CMOS IMAGER WITH INTEGRATED NON-VOLATILE MEMORY

Applicant: Christophe J. Chevallier
Serial No.: 09/136,680

Claims 1-28, as of December 11, 2002 (date of response to first office action filed).

FIG. 3

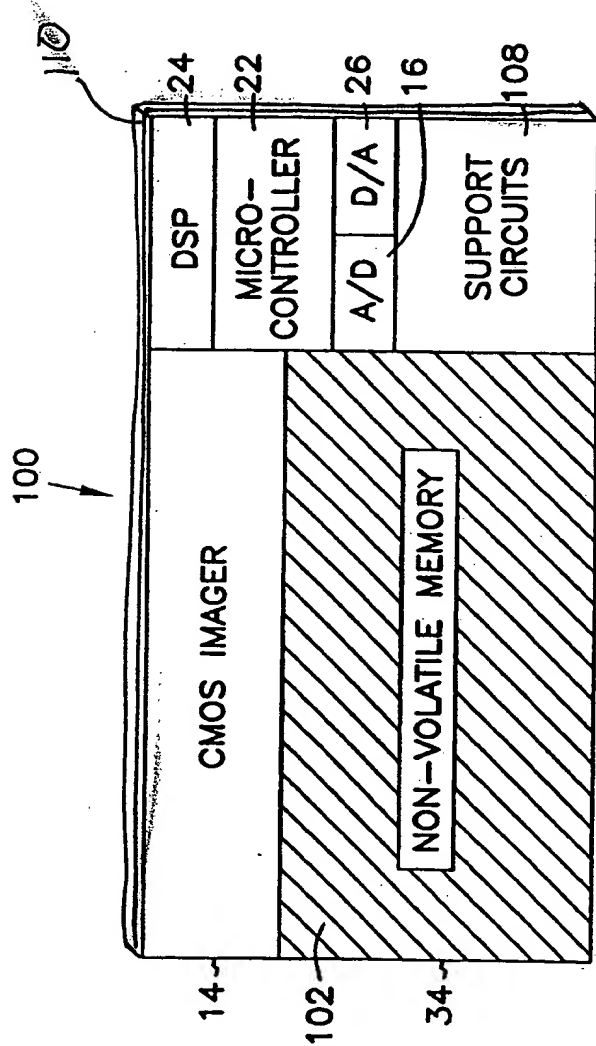
The disclosure is objected to because of the following informalities. In the specification, page 10, (lines 16, 28, and 29), page 11 (lines 2, 5-6, 8), all disclose "substrate 110." However, there is no disclosure of substrate 110 in figures 1-3. Applicant herein amends Figure 3 to include the substrate as described in the specification. It is believed that no new matter is proposed and the substrate is supported per 35 U.S.C. §112 in the specification. As the substrate is now included in Figure 3, withdrawal of the specification objection is requested.
